# Work Order ID 76662

Item ID: D412-664-203TRN Accept **\*N900040100\*** Setup Start **\*NS1\***  
 Revision ID: Stop **\*NS2\***  
 Item Name: Crosstube Turning Detail  
 Start Date: 18/11/2011 Start Qty: 1.00 **\*1\*** Cust Item ID:  
 Required Date: 02/12/2011 Req'd Qty: 1.00 **\*1\*** Customer:  
 Reference:

DRAWING NO. D412-664-243	TITLE CROSSTUBE ASSEMBLY (412 HI AFT)	REV. E	DART AEROSPACE LTD ENGINEERING ORDER		D.E.O. NO. D412-664-243-E-1	SHEET NO. SHEET 1 OF 2	SCALE NTS
DRAWN	CHECKED <i>MP</i>	MFG. APPR. <i>E</i>	APPROVED <i>MP</i>		DE APPR. <i>MP</i>		
DATE 11.03.31	DATE 11/03.31	DATE 11.03.31	DATE 11/03.31		DATE 11.03.31

REMOVED ABRASION STRIP IN FAVOR OF A THIN LAYER OF PROSEAL 890.

**D412-664-243  
ASSEMBLY DETAIL**

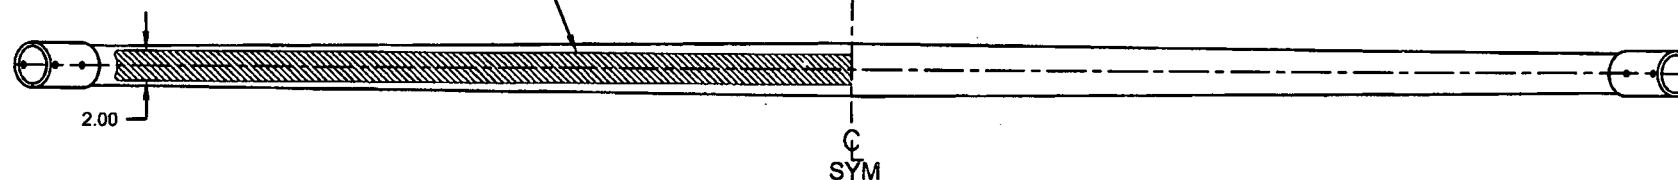
DRAWING NO. D412-664-243	TITLE CROSSTUBE ASSEMBLY (412 HI AFT)	REV. E	DART AEROSPACE LTD ENGINEERING ORDER	D.E.O. NO. D412-664-243-E-1	SHEET NO. SHEET 2 OF 2	SCALE NTS
DRAWN	CHECKED	MFG. APPR.	APPROVED	DE APPR.		
DATE 11.03.31	DATE 11.03.31	DATE 11.03.31	DATE 11.03.31	DATE 11.03.31

D3189-1 CHAFING SHIELD (1, INSTALLED OVER PROSEAL 890)  
MS21920-28 CLAMP, 2X  
2 PL

D2856-600-1009 ABRASION STRIP  
D3189-1 CHAFING SHIELD (1, INSTALLED OVER ABRASION STRIP)  
MS21920-28 CLAMP, 2X  
2 PL

2  
MASK AREA PRIOR TO PAINTING AND  
APPLY CLEAR COAT AFTER PAINTING
